UNITED STATES PATENT AND TRADEMARK OFFICE

APPLICATION NO.	FILING DATE	FIRST NAMED INVENTOR	ATTORNEY DOCKET NO.	CONFIRMATION NO.
10/647,568	08/25/2003	Alexis C. Weber	DP-310020	3258
22851	7590	09/21/2005	EXAMINER	
DELPHI TECHNOLOGIES, INC.			NGUYEN, TUAN N	
M/C 480-410-202			ART UNIT	
PO BOX 5052			PAPER NUMBER	
TROY, MI 48007			3751

Office Action Summary

DETAILED ACTION

annular rib engages the annular groove

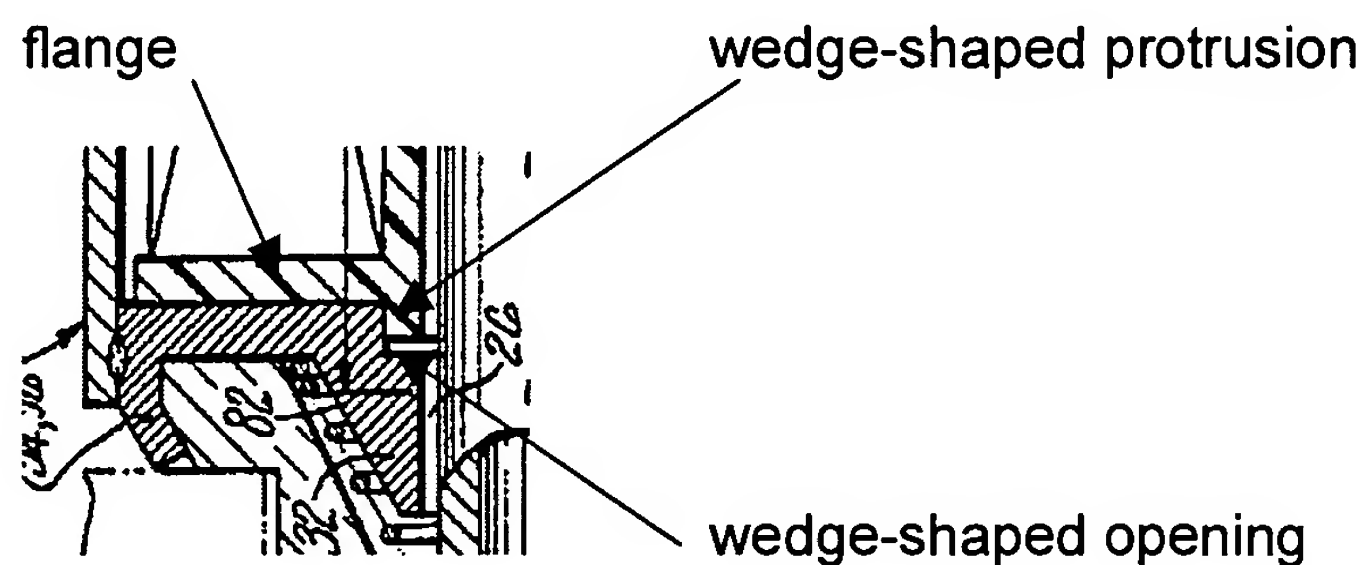
In regard to claim 1, Perach discloses a tubeless actuator comprising a frame (40), a primary plate (42,44) disposed within the frame; a secondary plate (34,36) disposed within the frame opposite the primary plate; and a bobbin (38) disposed within the frame between the primary plate and the secondary plate; an annular rib extending from the bobbin, an annular groove established by the secondary plate, and wherein the annular rib engages the annular groove to maintain alignment between the secondary plate and the bobbin (see picture below).
